NORTH FALLS

Offshore Wind Farm

Draft Marine Mammal Mitigation Protocol (Tracked)

Document Reference: 7.7
Volume: 7
Date: MayJune 2025
Revision: 23

Plate 1.2 Proposed piling mitigation procedures.

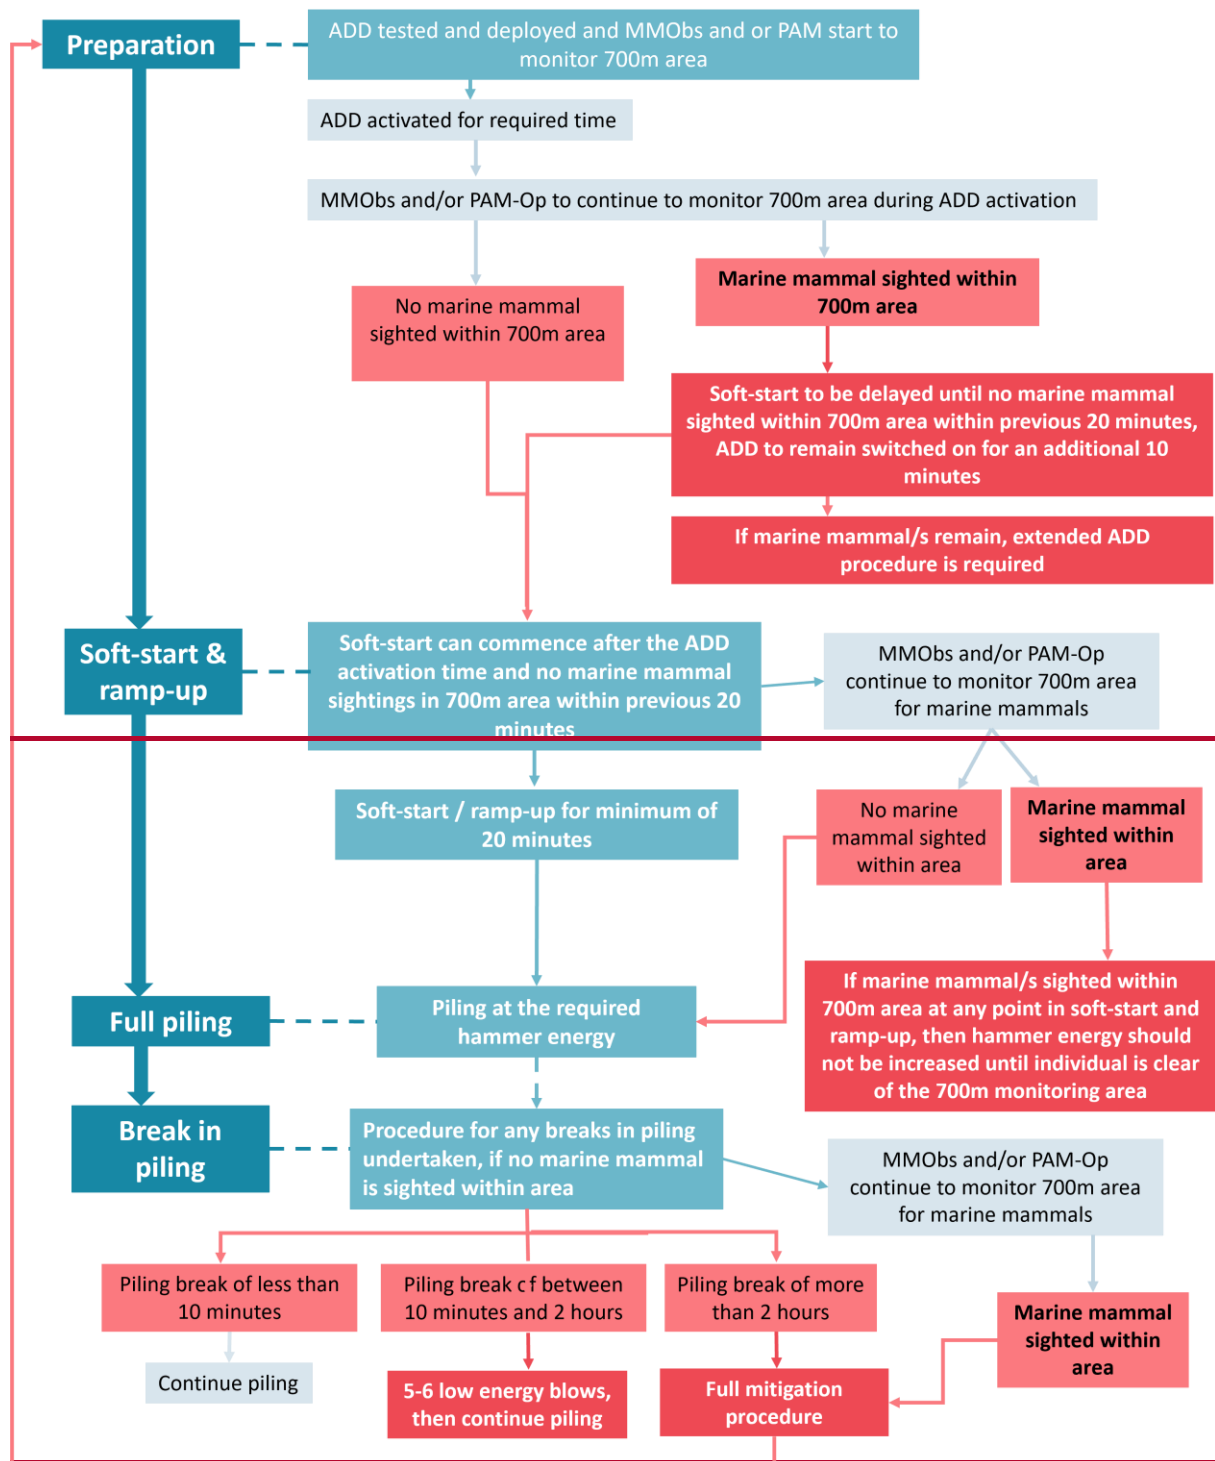
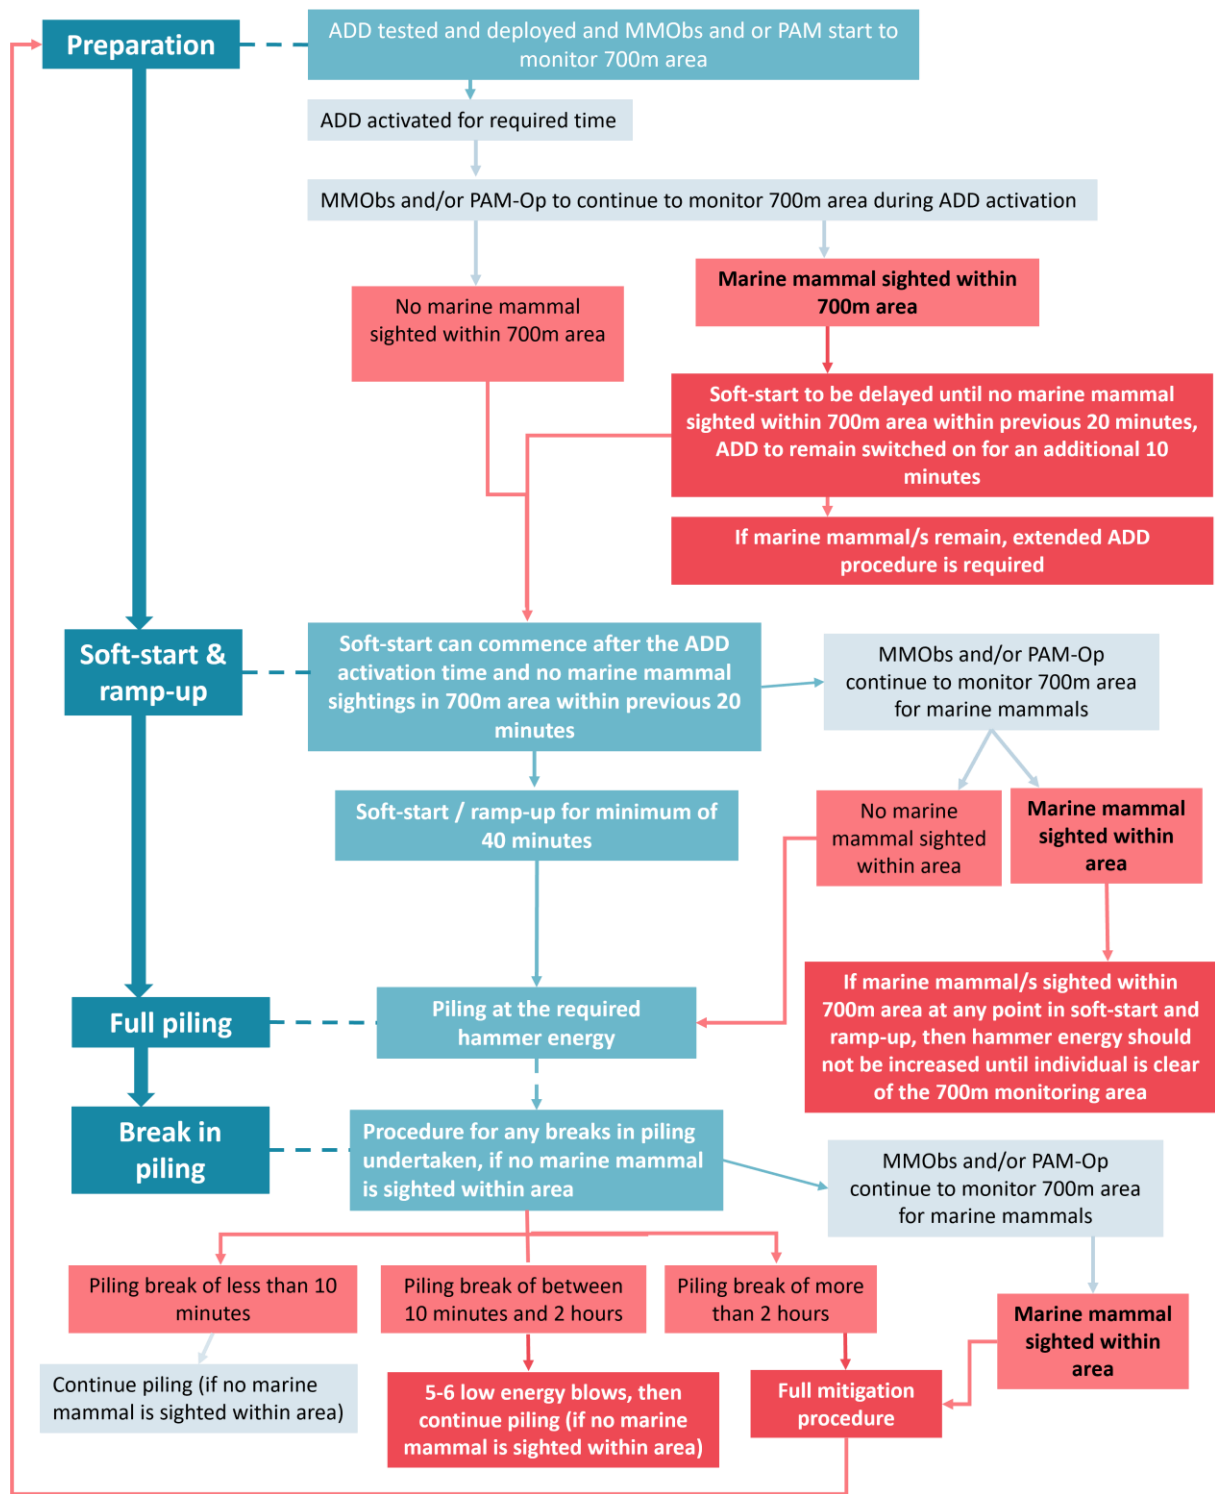
13. This version of the Draft MMMP (Revision 3) includes updates to Plate 1.2 to ensure it matches the text regarding soft-start and ramp up procedures, and to make clear that piling will only continue after a break if there are no marine mammals present.

Appendix B. Plots for Comparable Hammer Strike Energies

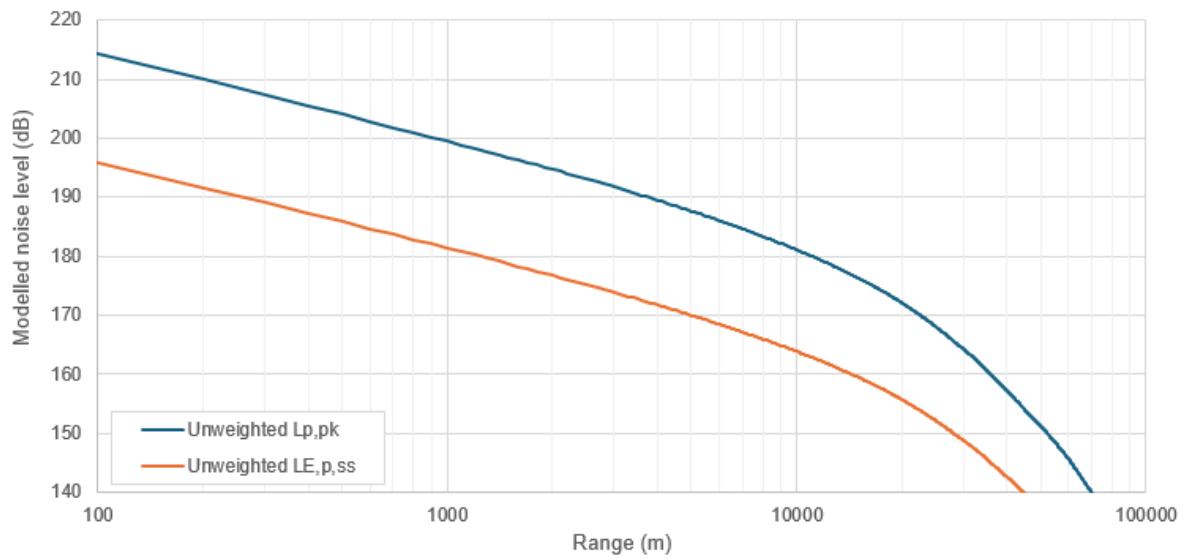
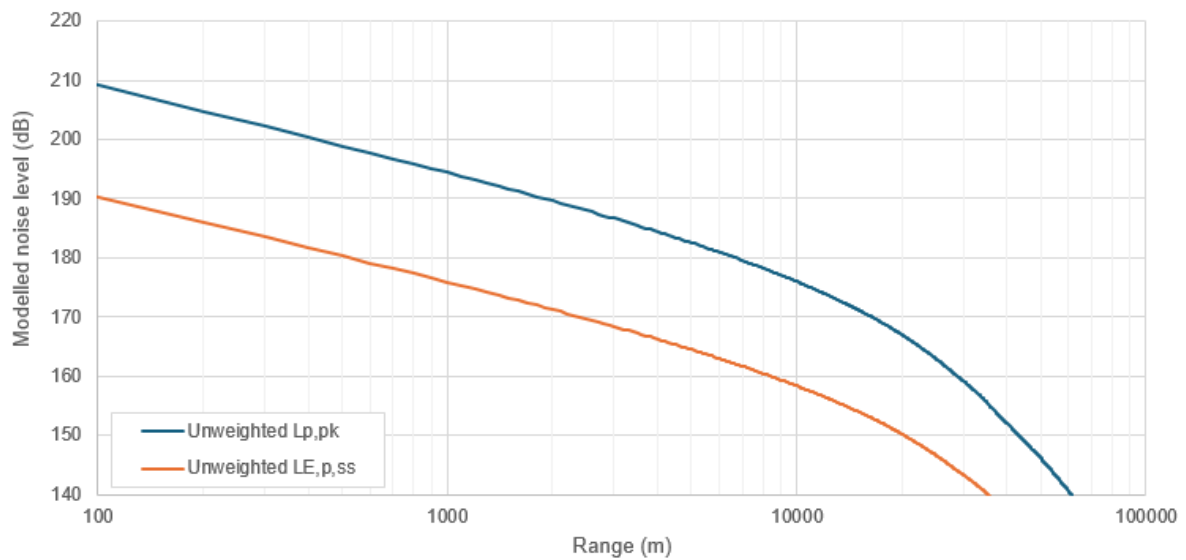
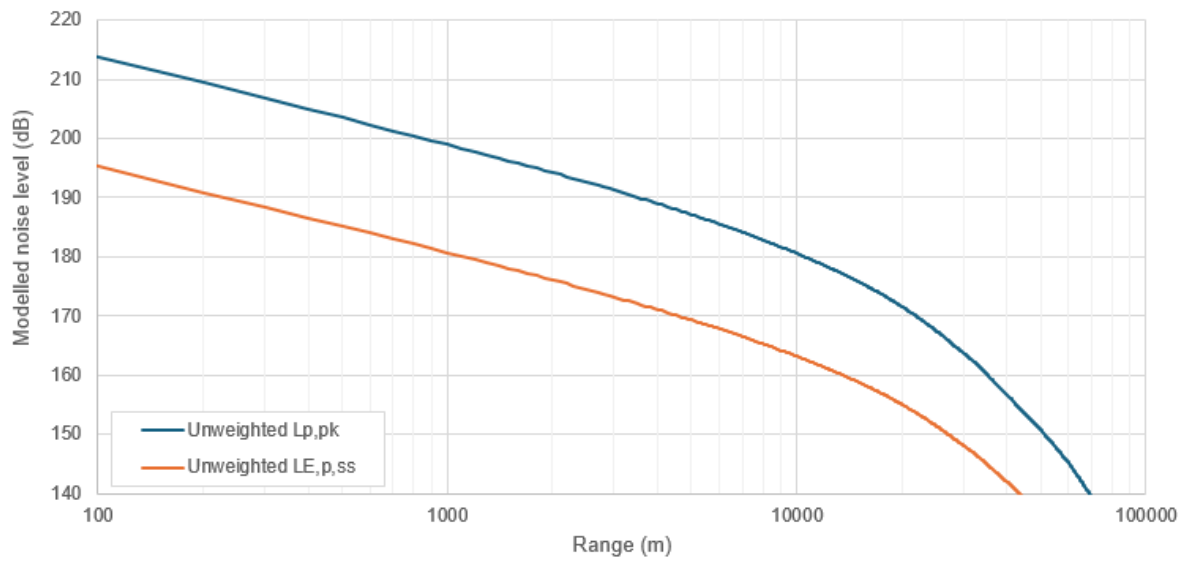
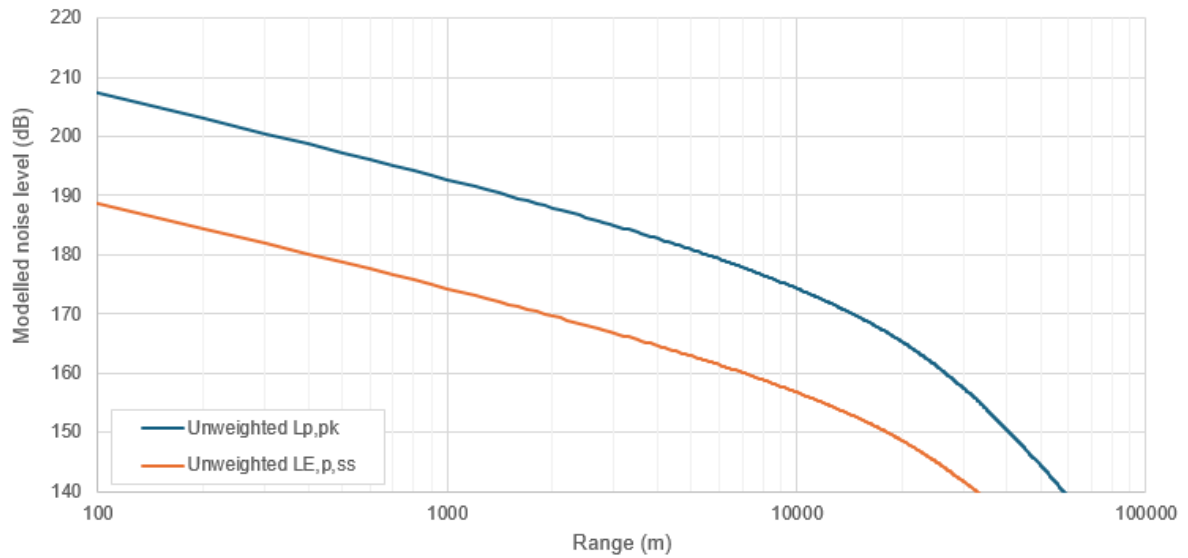
Consultee	Reference	Comment	Response / where addressed in the MMMP
		the final MMMP. The MMO suggests that the Applicant consults with the specific UXO contractor to determine the appropriate parameters for safely deploying bubble curtains. If environmental conditions are not conducive to the use of a bubble curtain, then the MMO recommends postponing any high-order detonations until conditions are suitable.	
MMO	MMO-195	The purpose of the noise monitoring during construction is to determine the actual underwater noise levels on site for comparison with the modelled levels presented in the ES. The MMO acknowledges that the measurements taken during installation will be constrained by various factors such as the piling plan and site limitations and a direct (like-for-like) comparison with a modelled scenario is unlikely to be possible. Nevertheless, even if the piling locations and choice of transects would not be matched precisely, both modelling and monitoring should provide enough information to deduce some envelope of received level curves in each case. Thus, some sort of comparison/s in the form of 'level vs range' plots (for comparable hammer strike energies), with the associated envelopes of variability, should be possible and would be expected. Therefore, the MMO recommends that such a plot is provided.	The Applicant has noted this comment from the MMO, therefore, these plots have been provided in Appendix B as part of the revised Draft MMMP (Revision 1).
